CITY OF OLYMPIA
Olympia Design Review Board

CONCEPT DESIGN REVIEW STAFF
REPORT
July 22, 2021

Project Name/Number:	Family Support Center of South Sound (FSCSS), Phase I, File 21-2734
Applicant:	Ayla Mull, Johnson Braund, Inc.
Location:	3524 7 th Avenue SW
Project Description:	Construct a 4-story building with 62 affordable apartments, surface parking for 62 vehicles, long- and short-term bicycle parking, an extension of Fieldstone Avenue and open space for residents. This proposal is the first phase in a two-phase development. In addition, the applicant has submitted a Binding Site Plan to create two lots, one for each phase of development.
Design Review District:	The project site is not within a design review district; however, is subject to the Multifamily Residential design requirements (OMC 18.170).
Zoning District:	PO/RM - Professional Office/Residential Multifamily
Comprehensive Plan Designation:	PO/RM – Professional Office/Residential Multifamily
City Staff:	Lydia Moorehead, Associate Planner Phone: 360.570.3746, E-mail: imoorehe@ci.olympia.wa.us

ENTRY FACADE

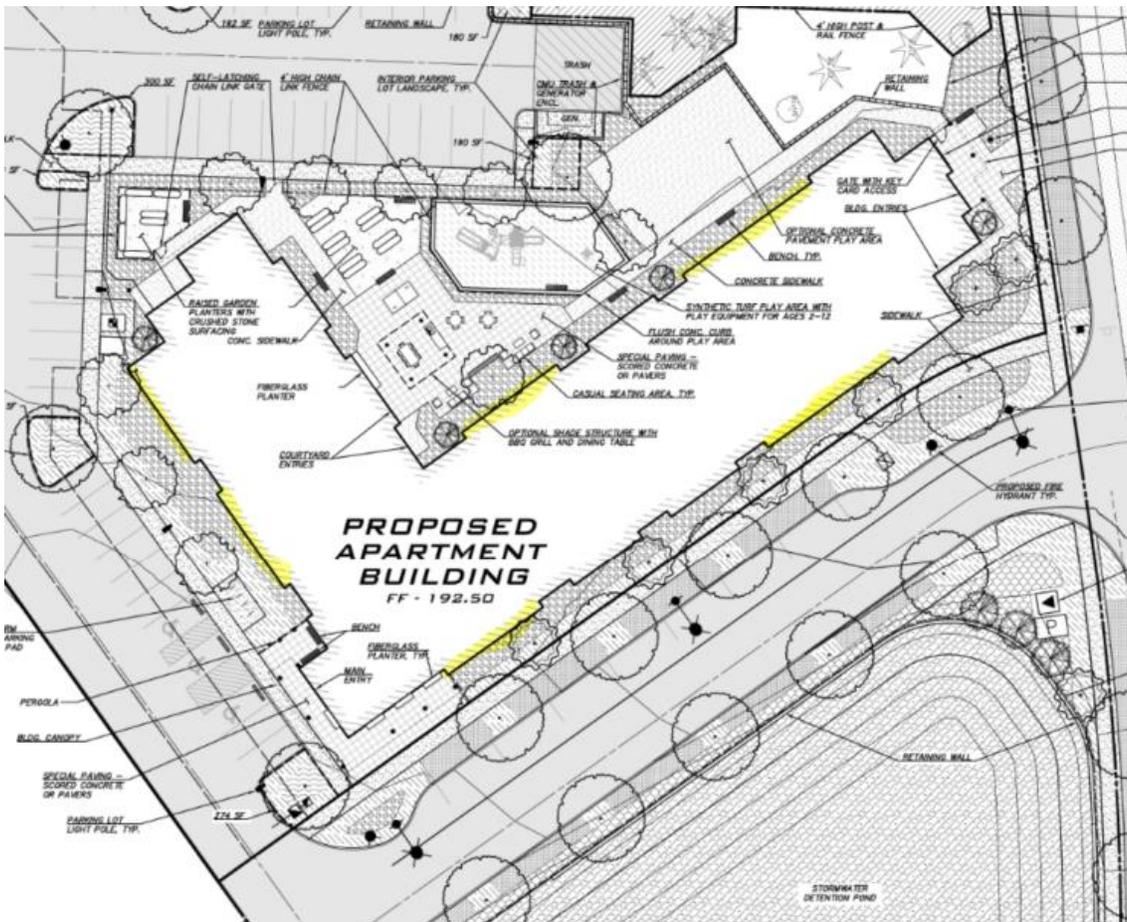
The applicant proposes variation in roof forms and variation (vertical & horizontal) in materials, colors, and window styles to reduce the appearance of larger building masses. The design guidelines specify methods to help break up building masses, some of which are employed. Those not used include porches, balconies and deeply recessed or protruding windows and/or light fixtures, trellises to accentuate modulation intervals along the areas exceeding 30 feet in length.

The larger expanses (43-45 feet) on the east and west facades do not appear to include any roof form changes, balconies, deeply protruding or recessed windows, or other architectural features, etc. Plans must be revised to either show precise modulation at 30 feet or the methods in which an equal or better design technique accomplishes what building modulation at 30-foot intervals would have.

The smaller expanses (32-33 feet) provide acceptable methods with roof form modulation, material, color, window variation and vegetation to break up the wall lengths. The roof form modulation is not a design requirement of any other multifamily design standard and provides equal or better treatment of building mass.

1. Provide design details for short-term bike parking shelters in the detail design packet. OMC 18.170.020.
2. Locate mechanical equipment and utility vaults on the least visible side of the building and/or site. OMC 18.170.070.
3. Screen or paint wall-mounted mechanical equipment to match the building. OMC 18.170.070.
4. Modify the larger wall lengths on the east and west facades to address lengths greater than 30 ft. in width or provide equal or better treatment of the two larger expanses. OMC 18.170.120.
